# Limited Energy Study of Hangar Facilities at Simmons Army Airfield (SAAF), Fort Bragg, North Carolina

*Final Report*

CONTRACT #DACA01-94-D-0034  
DELIVERY ORDER 0004  
SYSTEMS CORP PROJECT #94013.04

*RESPONSE TO  
INTERIM REVIEW COMMENTS*

Figure 1  
GAS  
DISTRIBUTION PLAN

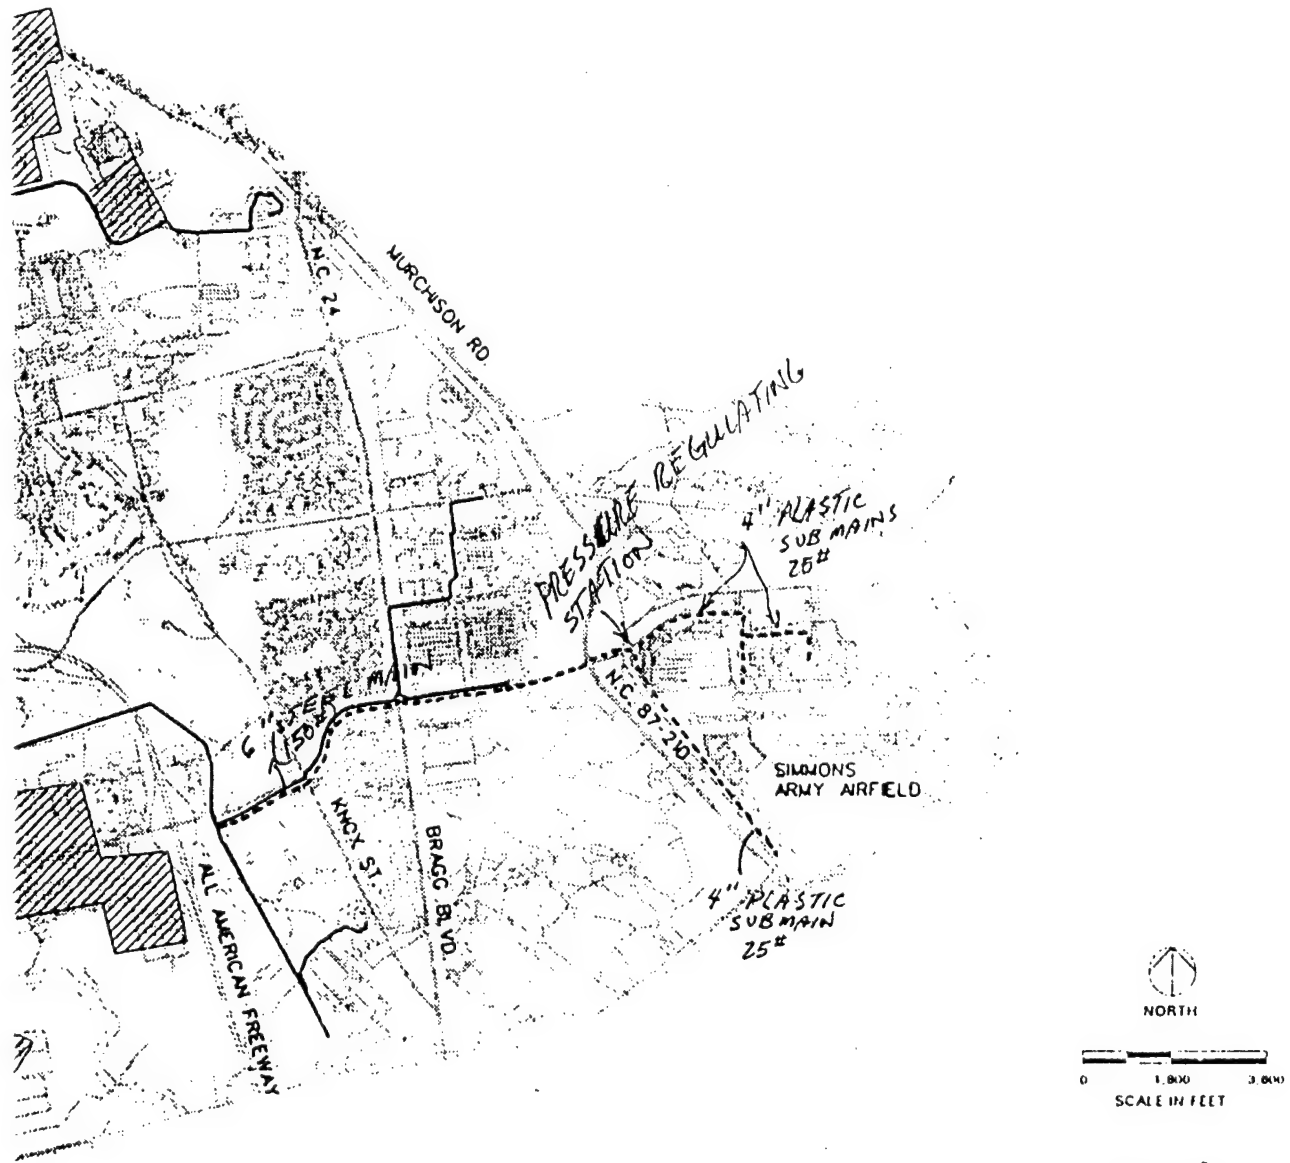
Comment No.	Vol.	Sec.	Page	COMMENTS <small><input type="checkbox"/> Struc. <input type="checkbox"/> Arch. <input type="checkbox"/> Civ. <input type="checkbox"/> Mech. <input type="checkbox"/> Elec. <input type="checkbox"/> San. <input type="checkbox"/> Env. <input type="checkbox"/> Fire <input type="checkbox"/> Other</small>	Action Code	RESOLUTIONS (include location of documents)	Ref.
1	2	8	4	Costs for pressure testing, overhead, bond, and subcontracting need to be added to cost estimate.	A	Costs have been added to cost estimates.	
2	2	8	4	Sixty psi, 4" line is stated. The gas company states that high pressure (150 psi), steel 6" line should be used to transport that distance.	A	Cost estimates have been revised to incorporate recommended changes by NCNG.	
3	--	--	--	A map showing the proposed gas line routing and distribution is needed.	A	Map has been included in Final submittal. See Section 5.3.2.
